WINSOME: PRELIMINARY PLAN AMENDMENT

LETTER OF INTENT

APRIL 2021

AMENDED SITE PLAN

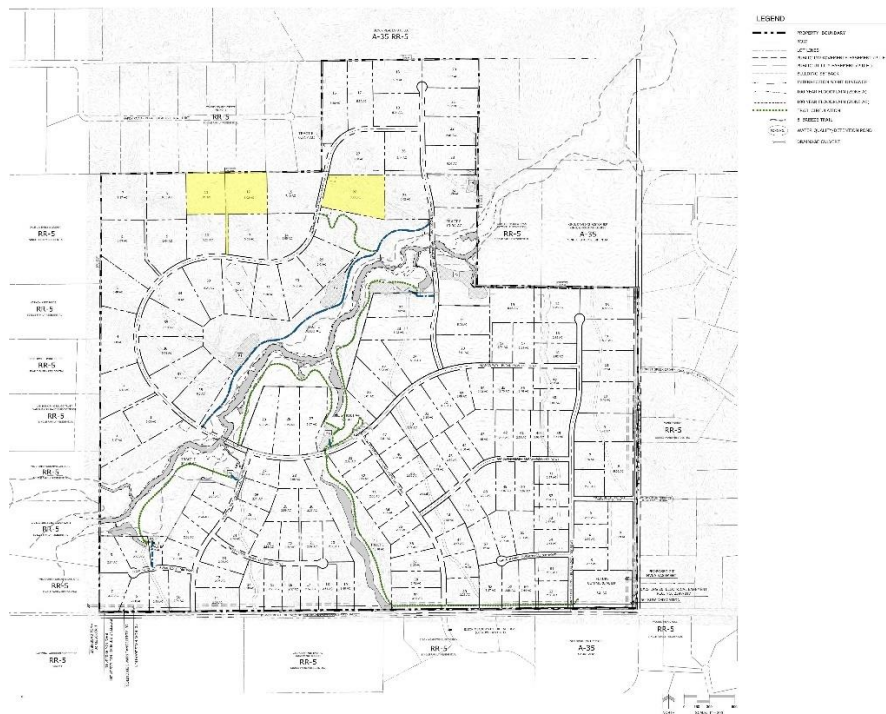
Update file no.
